285700 to 285799**SERVICE ENGINE****SALES MANUAL**
**MODEL 285700 SERIES ENGINES REPLACED WITH
STANDARD SERVICE ENGINES**

285700 to 285799

MODEL 285700

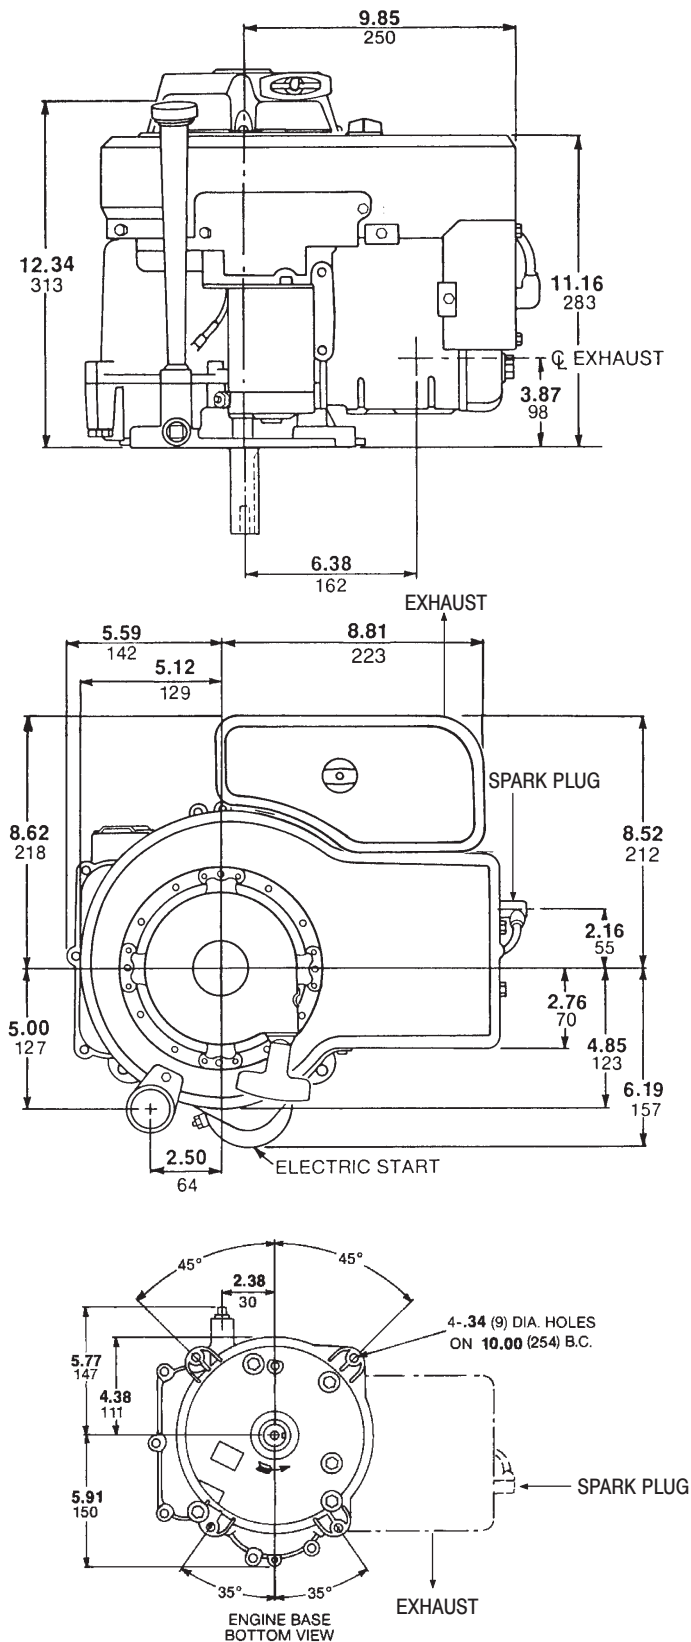
NOTE 33: If the replacement engine supersedes to or is a Model 210000 series engine, refer to the illustrations located after the conversion data for this model series. The overall dimensions which differ, are shown in the illustrations. If after making a visual inspection and it is determined the Model 210000 series engine cannot be used because of equipment interference, the original engine should be repaired with a short block and/or individual parts.
